SUBMITTER No.	364	ISSUE REFERENCE:	13001
SUBMITTER TYPE	Government	TOR CATEGORY	Project Approvals
NAME	DEEDI (Fisheries Qld)	RELEVANT EIS SECTION	Volume 1 – Chapter 2 – 2.2.2 – Table 3

SUBMITTER No.	364	ISSUE REFERENCE:	13002 / 17144
SUBMITTER TYPE	Government	TOR CATEGORY	Project Approvals
NAME	DEEDI (Resource Planning, Geological Survey of Qld)	RELEVANT EIS SECTION	Volume 1, Project Overview (Chapter 2 – Project Approvals) Section 2.2.2 – State Legislation & Planning Policies

Figure 1. Rail Infrastructure Crossings (Sheet 5 of 5)

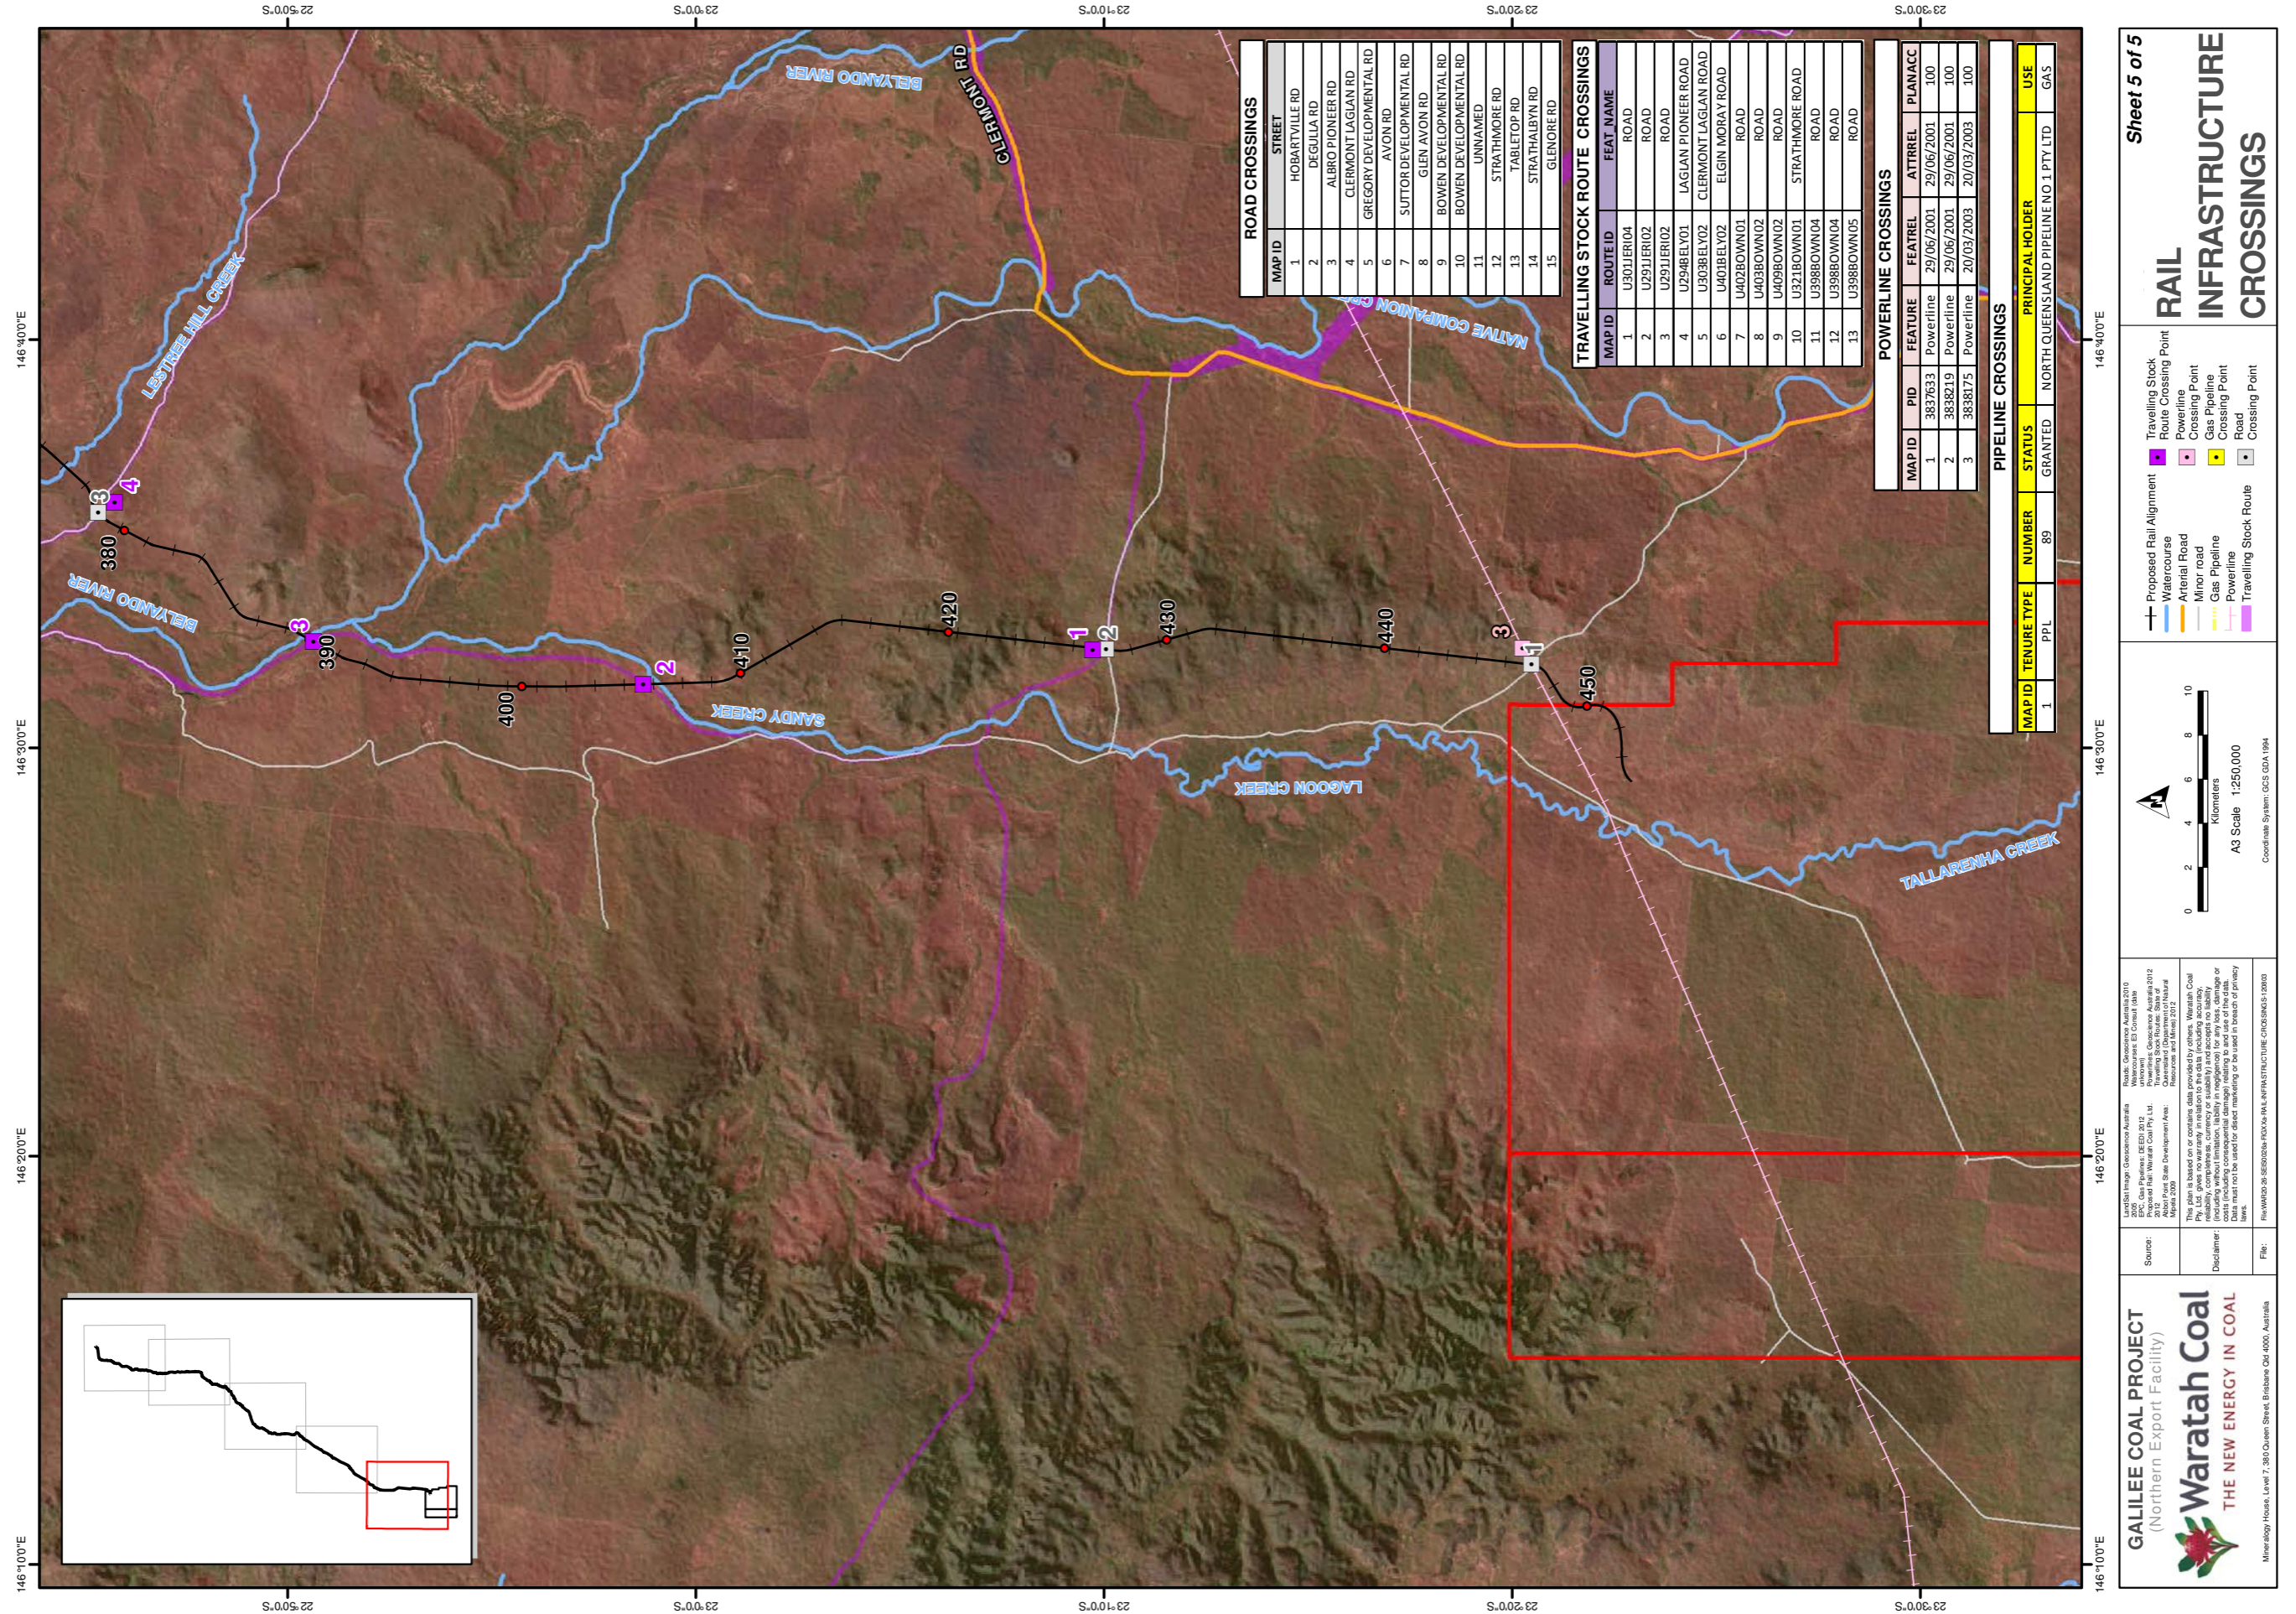
This section lists the relevant legislation affecting the Project. The proposed rail alignment traverses a constructed pipeline, the North Queensland Gas Pipeline (PPL 89).

Provisions of the *Petroleum and Gas (Production and Safety) Act 2004* (P&G Act) deal with activities affecting pipelines. This Act has not been identified in the draft EIS as part of the list of relevant legislation.

Reference should be made to the P&G Act, particularly Sections 807 and 808, which provide, respectively, that a person must not construct or place a structure on pipeline land without the prior consent of all the pipelines licence holders, and that a person must not change the surface of pipeline land without the prior consent of all the pipelines licence holders.

In accordance with the *Petroleum and Gas (Production and Safety) Act 2004* (P&G Act), Waratah Coal will obtain the necessary consents prior to undertaking any works over or near the subject pipeline.

Future studies regarding the portion of the rail alignment that traverses the North Queensland Gas Pipeline (PPL89) will take into account the provisions of the P&G Act. See Figure 1 (Sheets 1 to 5) on the following pages.
